Re: Leaning Juniper IIA Wind Power Facility – Amendment Determination Request

LEANING JUNIPER IIA WIND POWER FACILITY

AMENDMENT DETERMINATION REQUEST

DECEMBER 12, 2024

## Figure 1 Alternate Crane Path Location

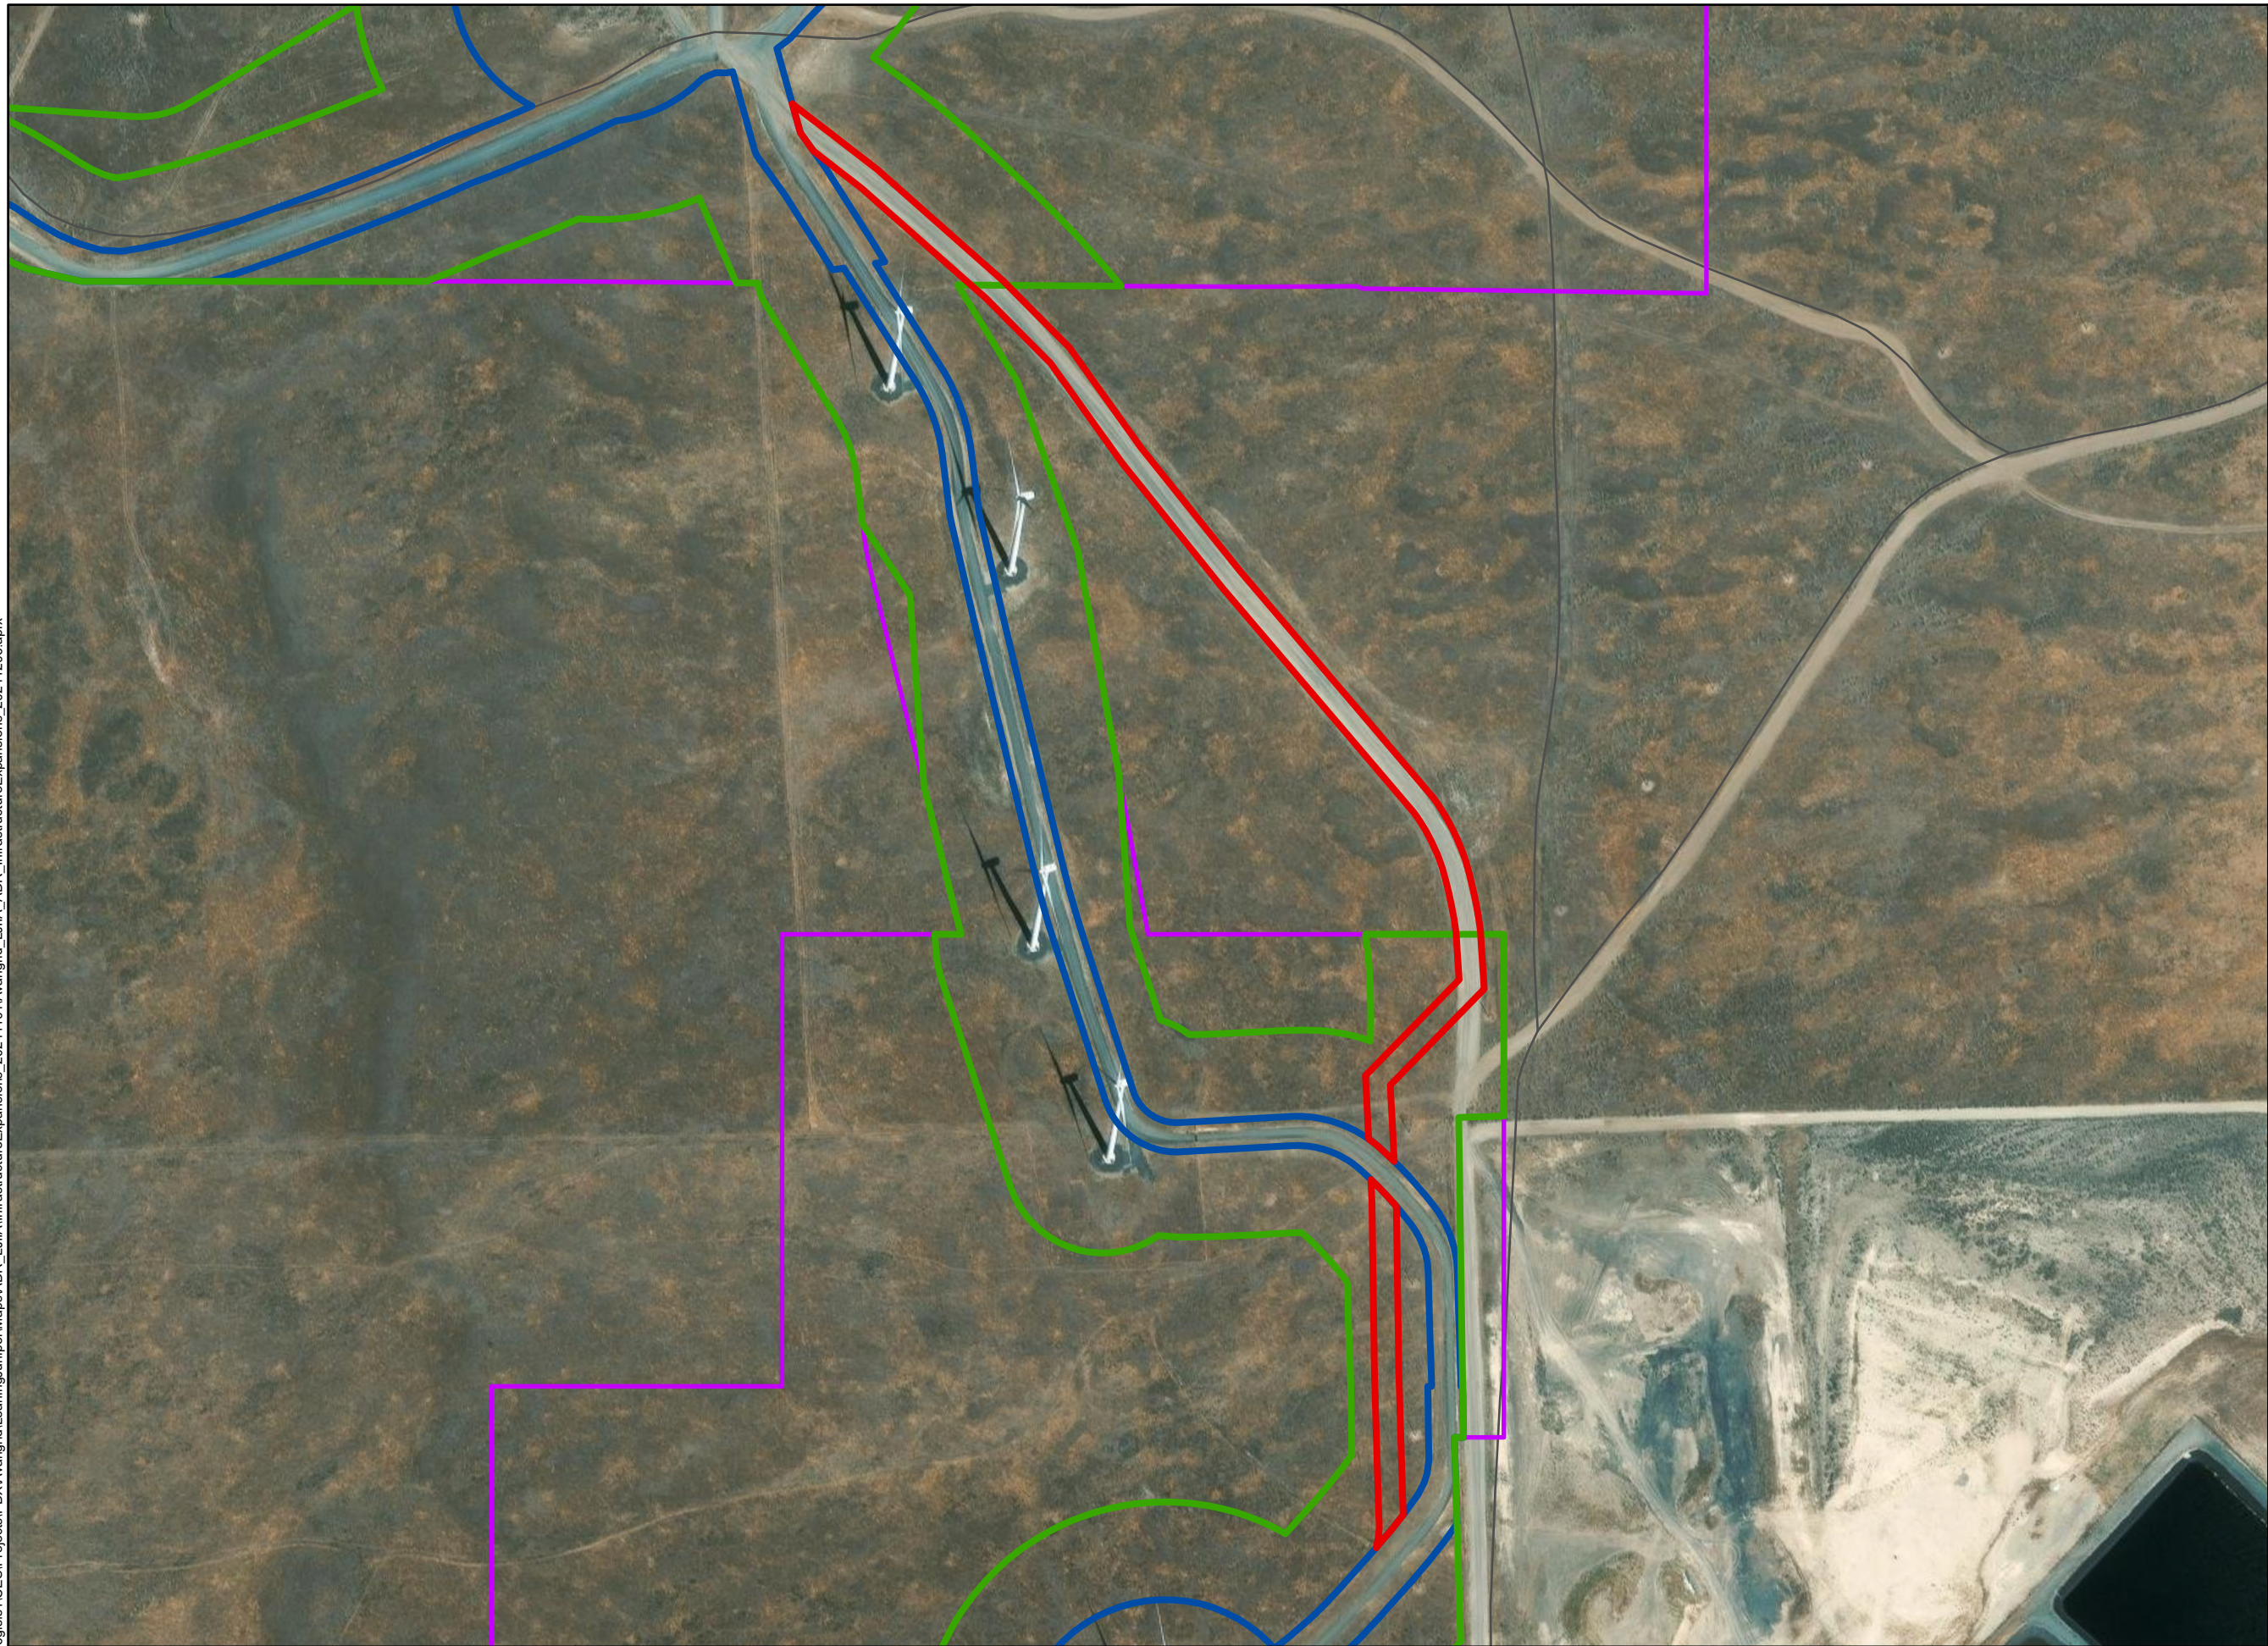
Certificate Holder needs to walk the turbine crane between two turbines (Turbine M1 and Turbine K2) to avoid potential safety hazards with walking the crane past operating turbines that will not be repowered (see Figure 1). To avoid this route, the modified route of least disturbance requires Certificate Holder to use a temporary crane path that relies, in part, on an existing roadway outside of the Facility site boundary (northern portion). The southern portion of the temporary crane path, after the path leaves the existing road, would be within the repower micro-siting corridor as shown on Figure 2 of the Final Order on Amendment 3 (ODOE 2024, p. 7). The repower micro-siting corridor (green), original estimated limits of disturbance (blue), and the new temporary crane path (red) are shown in Figure 1. Certificate Holder proposes to use this crane walk once during the repower activities, for approximately two to four hours when walking the crane between Turbine M1 and Turbine K2.

The temporary crane path will be within the repower corridor that has been surveyed (except as noted below for WGS) or on an existing roadway that is already disturbed and not considered a

## Figure 2 Alternate Crane Path – Washington Ground Squirrel Survey Area

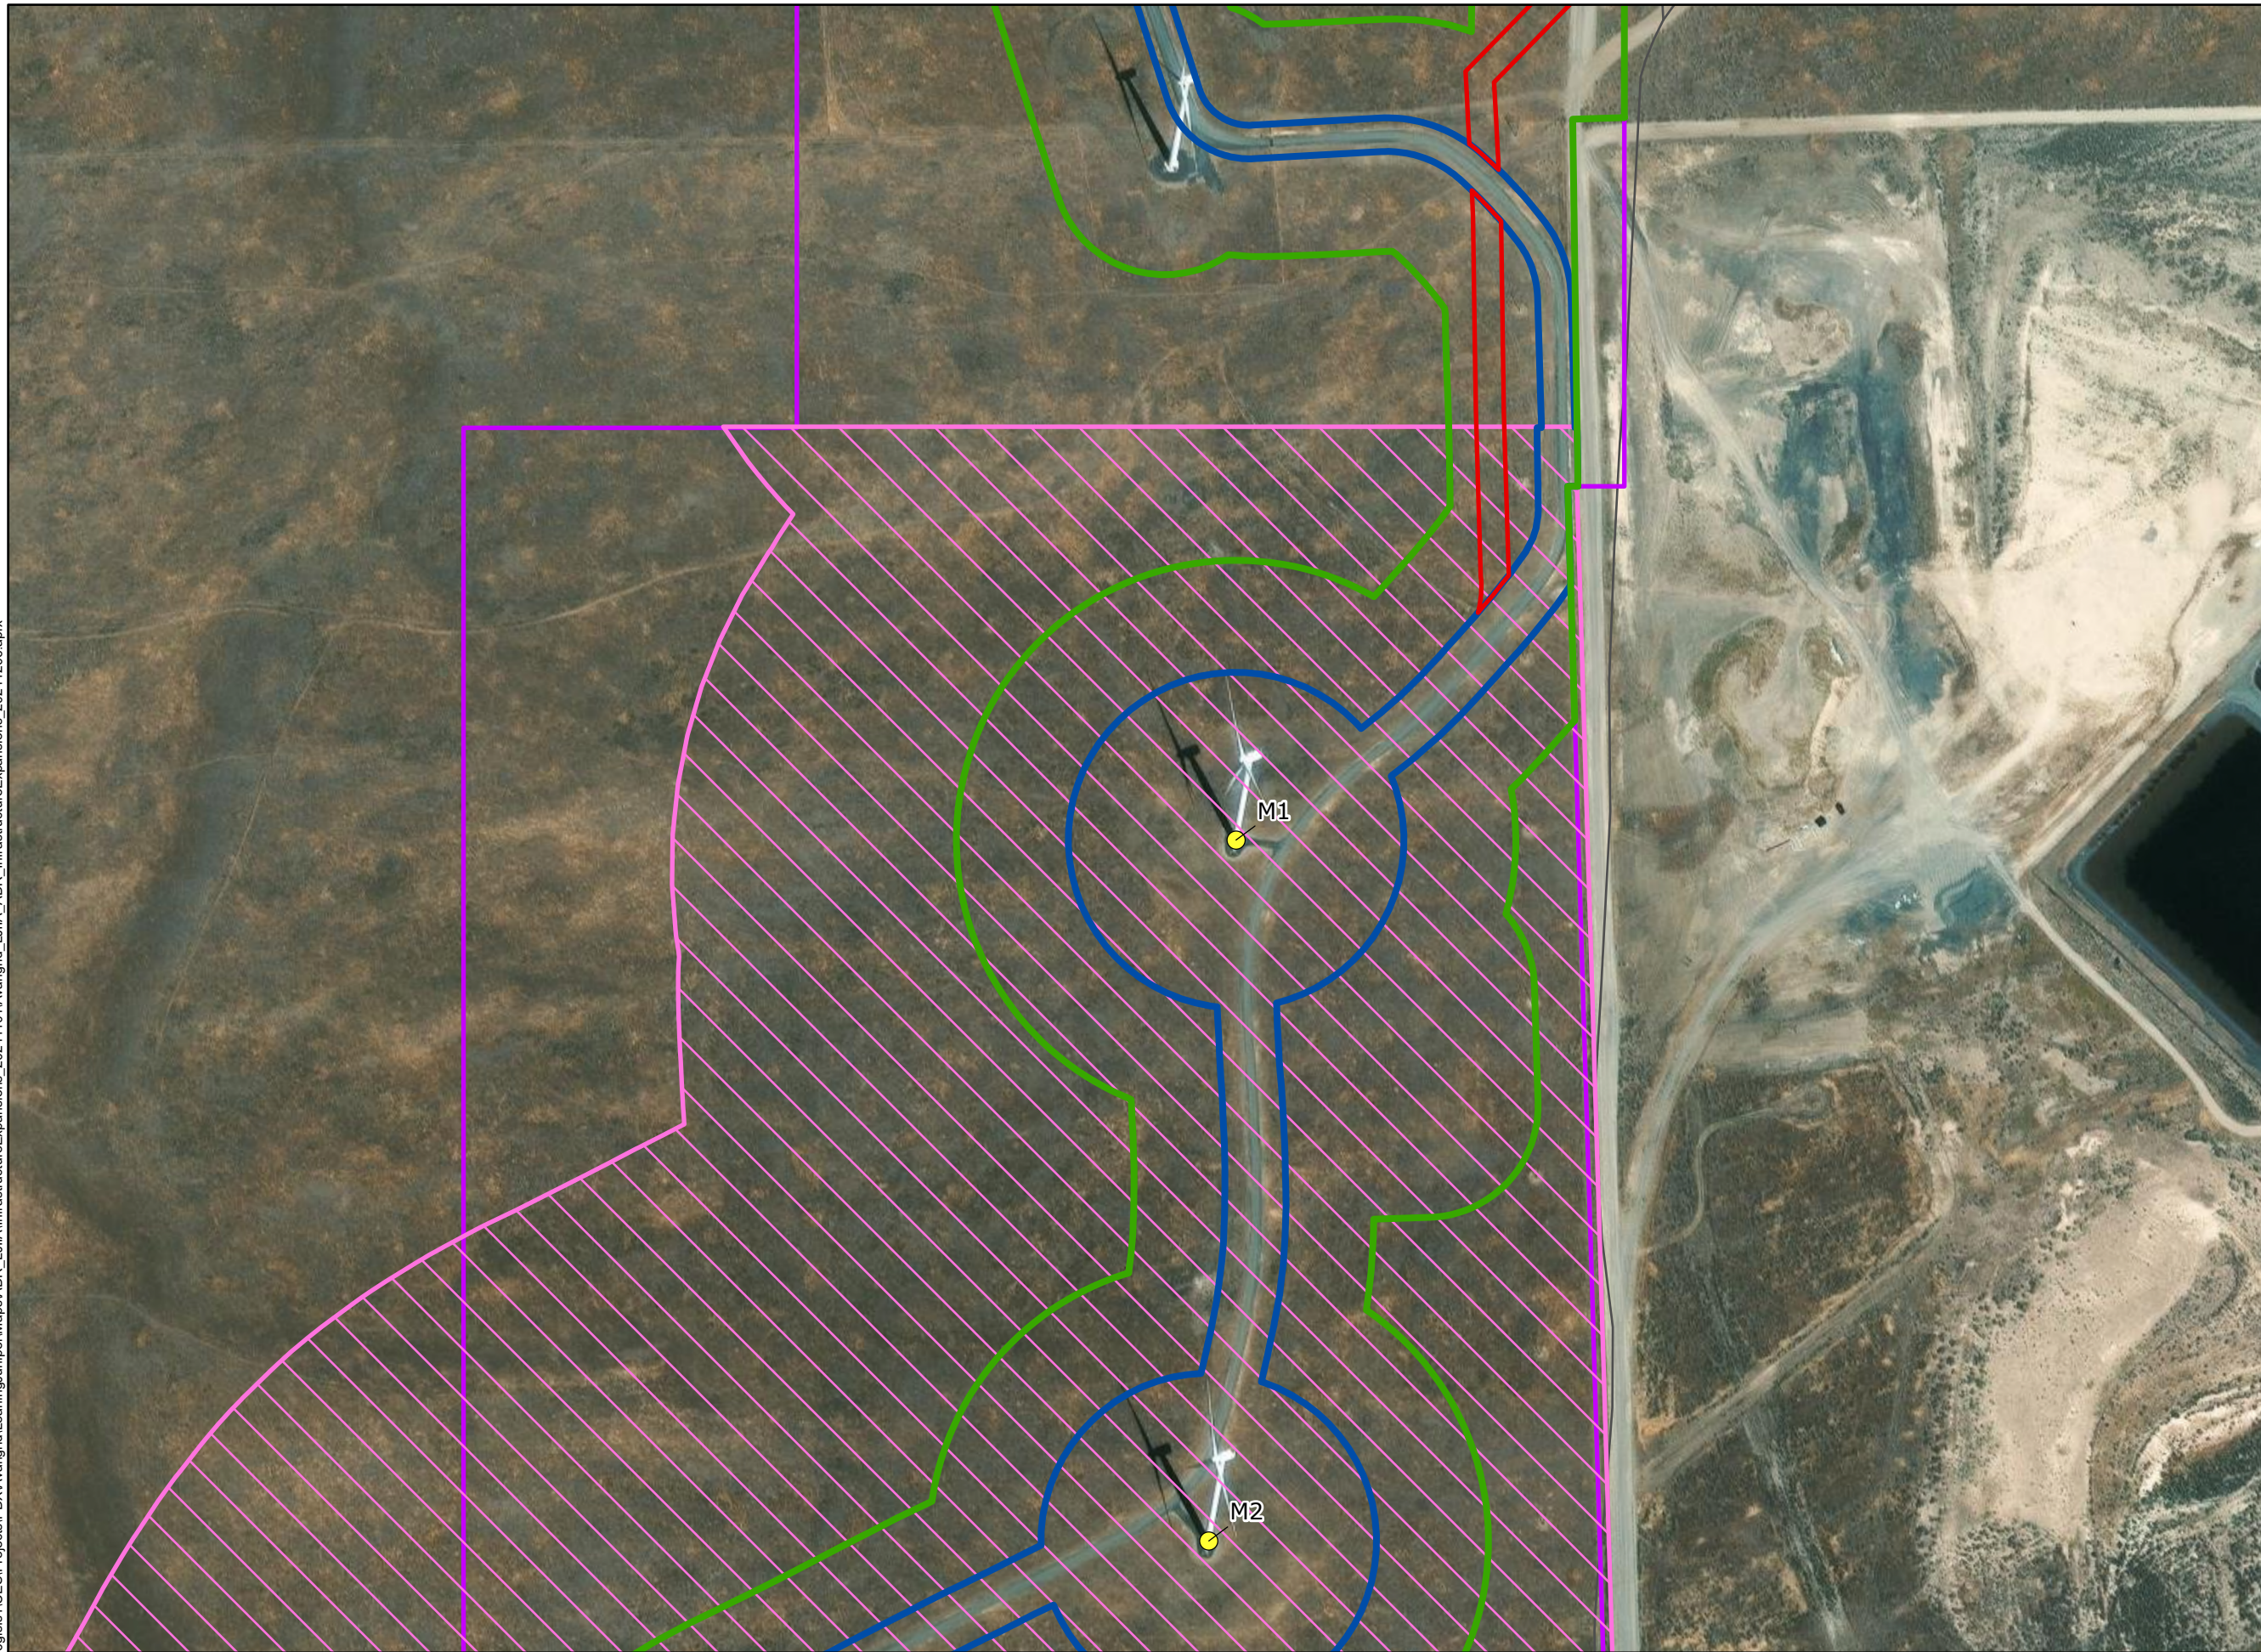
related or supporting facility. The repower microsite corridor was already surveyed for habitat, rare plants, and cultural resources. No wetlands or cultural resources were identified during surveys of this portion of the repower microsite corridor, and the area is mapped as Category 3 shrub-steppe habitat. All anticipated temporary disturbance has been previously evaluated and any temporary impact to Category 3 habitat will be mitigated in accordance with the Habitat Mitigation Plan. Approximately 500 feet of this new crane path, where the path would move off of the existing road to avoid overhead lines, was not surveyed for WGS (see Figure 2).

Certificate Holder does not anticipate using the temporary crane path until May 2025 or later, and plans to conduct protocol-level surveys within 1000 feet of the proposed disturbance area during the appropriate survey season in April 2025. Certificate Holder will provide a supplement to the 2023 Washington Ground Squirrel Report for ODOE and ODFW review and approval. Certificate Holder points ODOE to Condition 84 in the Site Certificate to assure that this work will be done and Certificate Holder will remain in compliance with Site Certificate conditions. Condition 84(e) of the Site Certificate provides that if construction would affect microsite areas that were not previously surveyed for WGS, Certificate Holder shall construct pre-construction surveys for those locations, notify ODOE of the findings, and implement appropriate avoidance and mitigation measures. Condition 84 is one of the conditions noted in the Site Certificate as being no longer being applicable to repower activities, however, ODOE did note that non-applicable conditions are kept in the Site Certificate “should there be a future change or facility modification for which certificate holder seeks to complete at the site and may rely on compliance with preconstruction and construction conditions to evaluate potential impacts and or need for a site certificate amendment given protections afforded through these historic conditions.” See Site Certificate, p18 Lines 24-28. It is clear from the Site Certificate language that this is the exact situation where a previously-imposed condition may be relied upon to ensure that impacts from the proposed modification are appropriately evaluated and impacts are avoided. The language also implies Certificate Holder, and ODOE, may rely on Condition 84 to avoid triggering and amendment to the Site Certificate.

If WGS are found during the Spring 2025 surveys, Certificate Holder will coordinate with ODOE and ODFW to determine the appropriate course of action to remain in compliance with Site Certificate conditions and protect WGS colonies and habitat.
